DESIGN RESPONSE CONFERENCE

**8505 132nd Avenue NE
Kirkland, WA**

From: Cassandra Stout <sagansjagger@gmail.com>
Sent: Friday, November 22, 2019 10:28 AM
To: Design Review Board; Tony Leavitt; Kurt Triplett
Subject: Public Comment on Continental Divide Project DRV18-00312

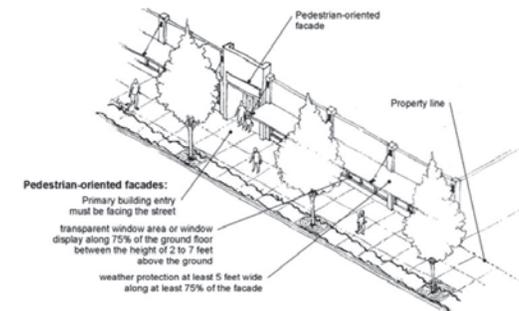
“GIVEN THE 3 OPTIONS IN FIGURE 19, PAGE 15 OF THE DESIGN GUIDELINES FOR ROSE HILL EAST END NE 85TH STREET FRONTAGE, WHICH IS A SUPERIOR DESIGN TO THE STATED SETBACK REQUIREMENT?”

Considering that the goal of the policy basis is to create pedestrian friendly storefronts on NE 85th Street, the top option (shown below) is the one that conforms with best planning practices to have the storefronts right at the edge of the sidewalk. That is, at the property line where the pedestrian interface occurs; not setback from the property line. Note that in this Design Guideline recommended option, the building is placed such that the storefronts are at the property line.

1 SITE PLAN - LIGHTING
SCALE: 1/16"=1'-0"

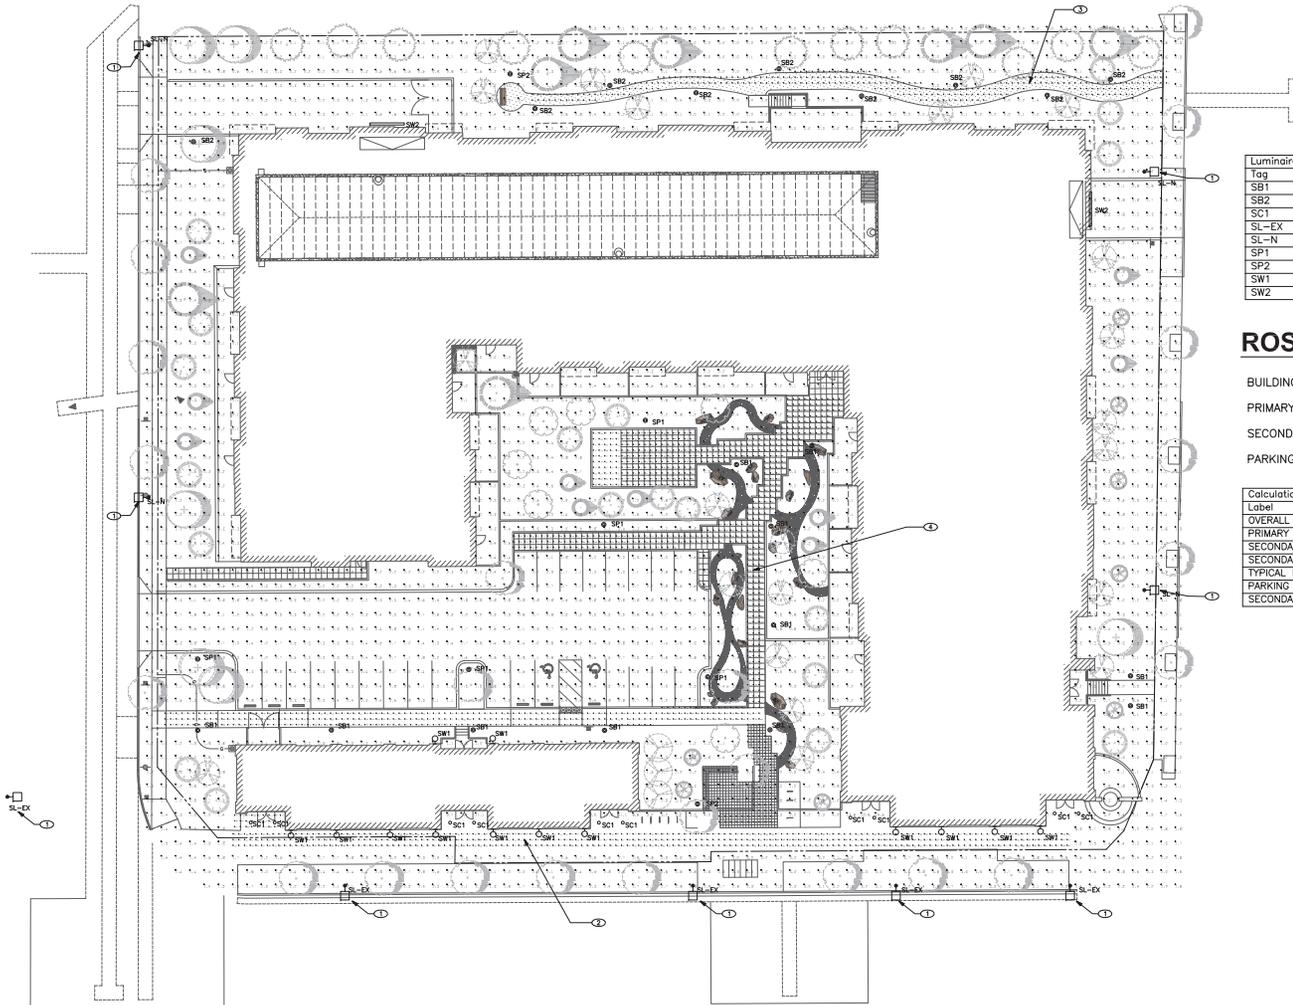
2. LIGHTING PLAN

- Submit a lighting plan that addresses the Design Guidelines contained in Section 9 - Lighting.

ITEM 4 | ELEVATIONS

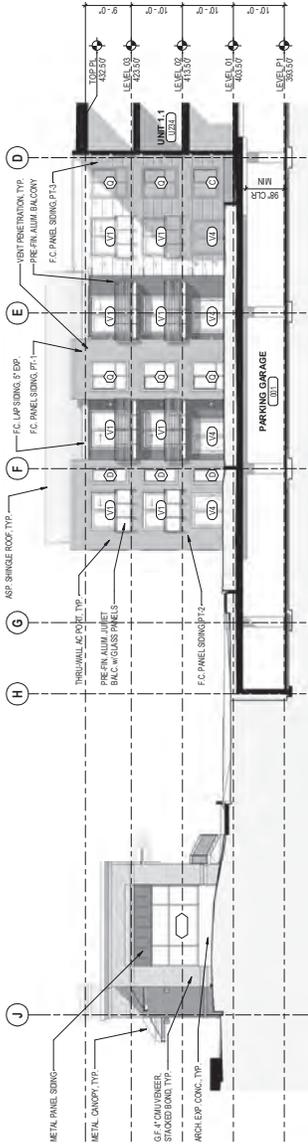
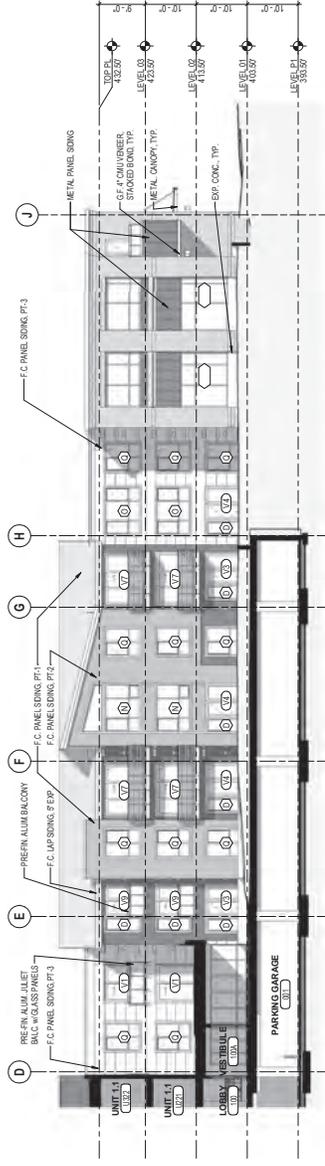
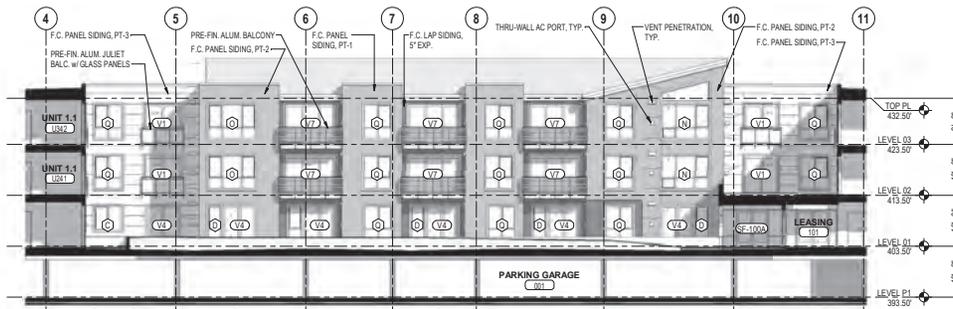
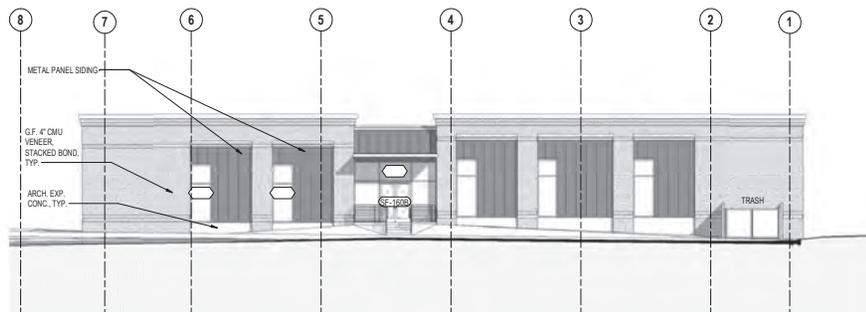
- Provide elevations for all facades for each building including the north facade of the standalone commercial building.

ITEM 8 | BLANK WALLS

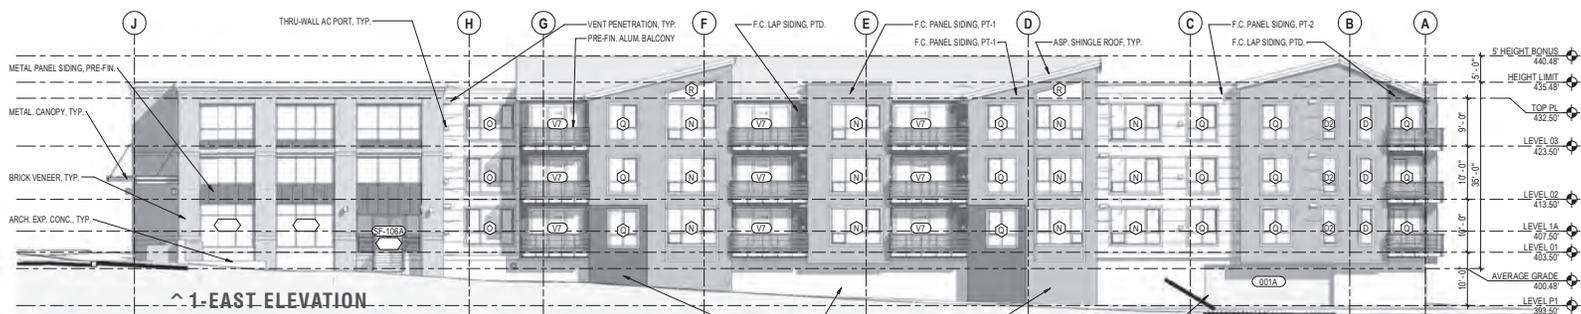
- Additional development of the standalone commercial facade to create a superior design to offset the modification request. Ideas include material changes on the parapets and cornice treatments. We recommend looking at the Hectors Building on Lake Street and the Park Lane Public House for some ideas.
 - a. Also address any blank walls on the backside of the building (See Design Guideline Section 8)
